## Planning Committee A

**DEEPDENE POINT, DACRES ROAD, LONDON, SE23 2BN.**

**Date:** 25 May 2023

<b>Application reference number(s):</b>	DC/23/130571
<b>Application Date:</b>	28 February 2023
<b>Applicant:</b>	Arcus Consulting LLP
<b>Proposal:</b>	Refurbishment of external cladding, replacement of windows, doors, balconies, screens and roof finishes at DEEPDENE POINT, DACRES ROAD, LONDON, SE23 2BN.
<b>Background Papers:</b>	(1) Submitted drawings and documents (2) Submitted photos (3) Internal and external consultee responses
<b>Designation:</b>	PTAL 2
<b>Screening:</b>	N/A

Figure 2 Existing and proposed South West and North East

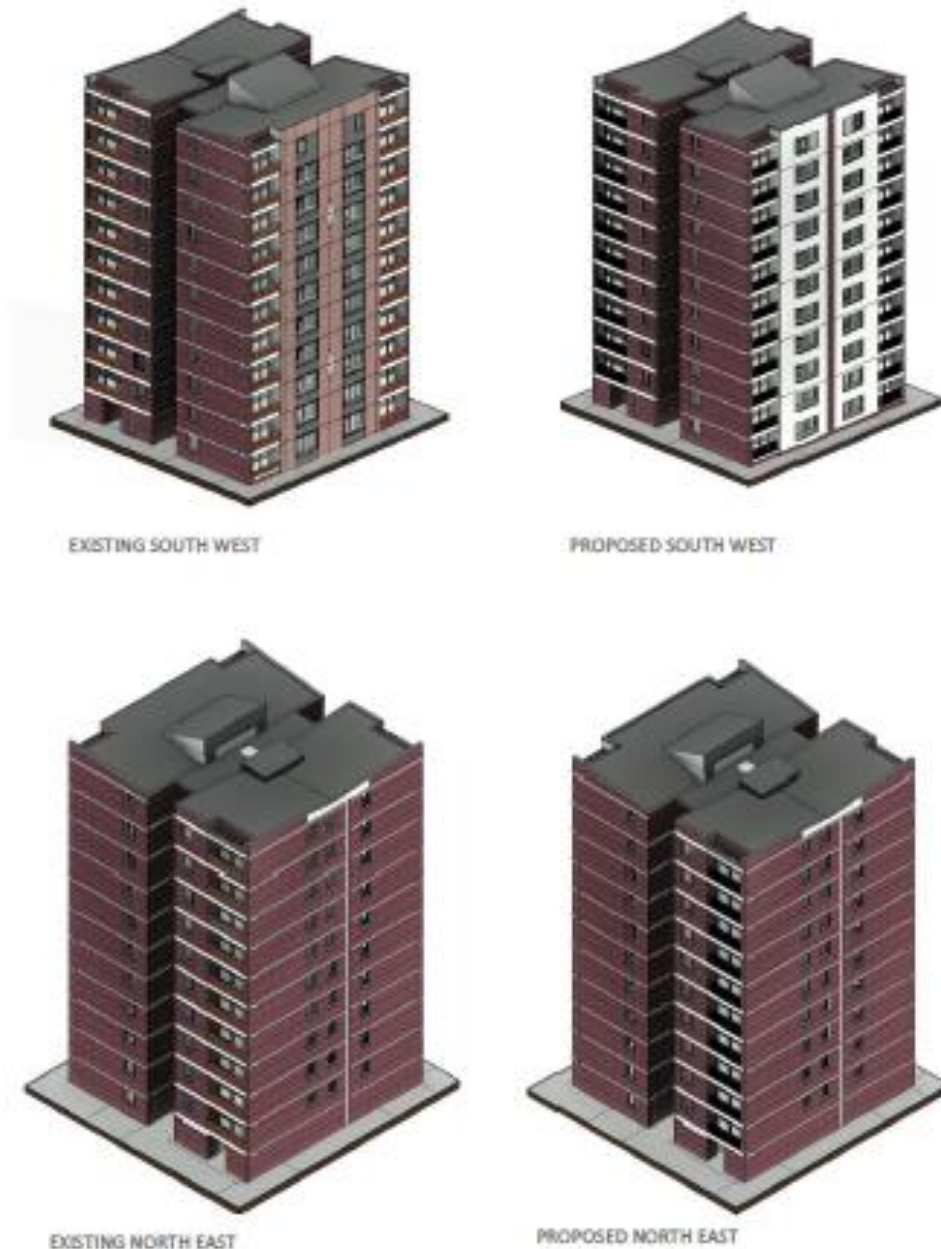
55 The existing windows are white uPVC. The proposal is to install new white uPVC double glazed in the same place and size of the existing windows and doors, style to match original. New double-glazed windows and screens are proposed to achieve a u-value performance of 0.16 W/m<sup>2</sup>K. In the D&A statement it is pointed out that installation of the new Rehau 70mm uPVC would achieve the requirements of BS EN12608:2016, Table 1.4 of Approved Document F and Approved Document K. The windows would have sills, and trickle vents, with tilt and turn hinges and restrictors, with locking handles in white. All windows with a sill height below 1000mm will require the installation of a lower-level fixed pane below the opening vent to enable the required sill height for the opening vent.

57 The windows and doors would be the same style, material, and colour as the existing. Objections were raised questioning the quality of uPVC windows: the windows proposed are of good quality and would be similar to these use on many residential buildings and are considered unobjectionable. The new double-glazed windows would improve the building's performance in terms of energy efficiency, and sound isolation, and are supported.

**Figure 3 Existing and Proposed South East and North West**

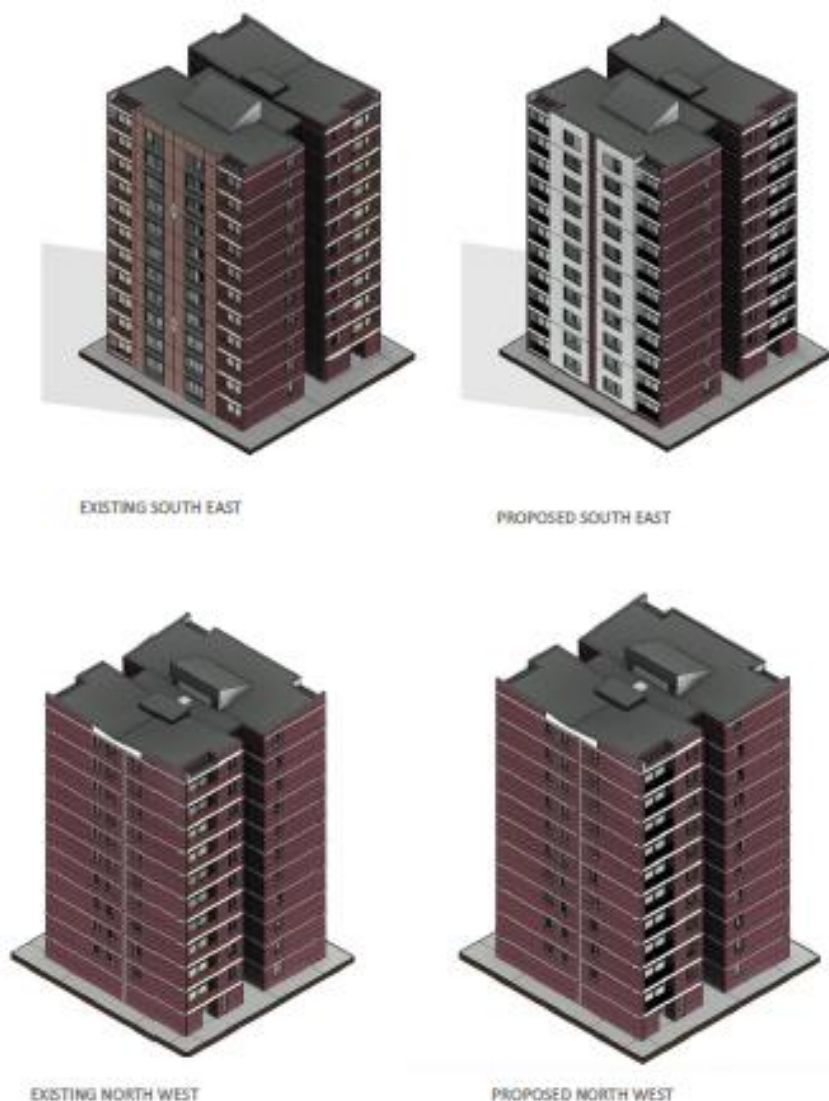
- 60 The doors to the flats would be new Rehau residential uPVC doors finished in white glazing (28mm Sealed Units) and multipoint locking mechanism to achieve the requirements of BS EN12608:2016.
- 61 New external glazed timber screens and doors to the central access core are proposed to ensure compliance with current fire safety legislation, by a minimum u-value of 1.6 W/m<sup>2</sup>K to achieve the requirements of the building regulations.
- 62 The doors to the storage spaces at ground floor would be replaced with new FD 30 timber doors. The existing plantroom steel doors would be repaired and painted.
- 63 The proposed doors and screen are considered as enhancement to the existing conditions and are supported.

**Figure 4 Proposed Balustrade**

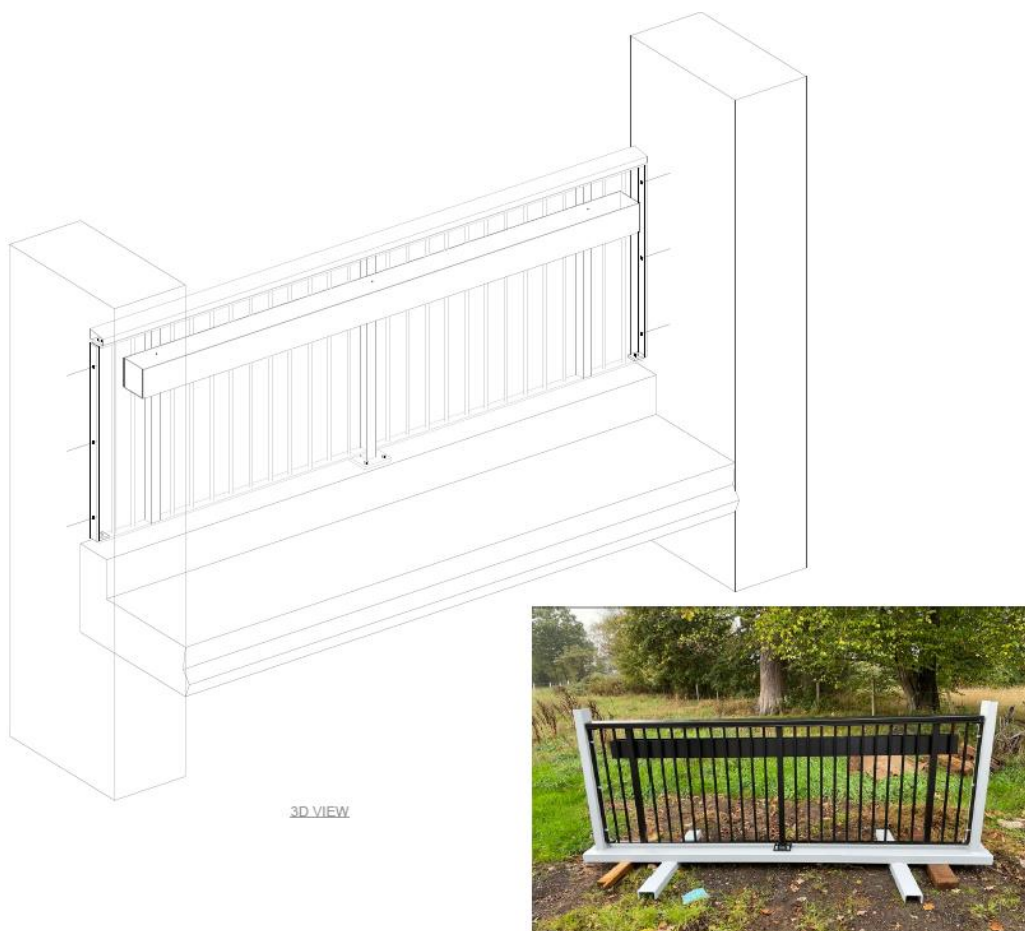
- 64 The existing timber balustrade at the balconies would be replaced with polyester powder coated aluminium balustrades to ensure compliance with both Approved Documents Part B and Part K. The colour would be dark grey RAL colour: 7022. At the ground floor the existing masonry upstand would be retained, and the timber balustrade would be replaced with the railing.

- 66 Objections were received regarding the change of existing timber balustrades with metal railings. It is noted that timber balustrades at balconies of all the five towers in this area are considered as an original character of these buildings. The replacement with metal railings is not considered inappropriate nor incongruous as this is a standard residential balcony enclosure. It is notable that, due to changes in the Building Regulations regarding fire safety, timber balustrades for high rise buildings such as this tower, are no longer supported.

- 67 Officers are of the view that the current timber balustrades are in poor condition, and considering the quality of the proposed materials, they are acceptable.
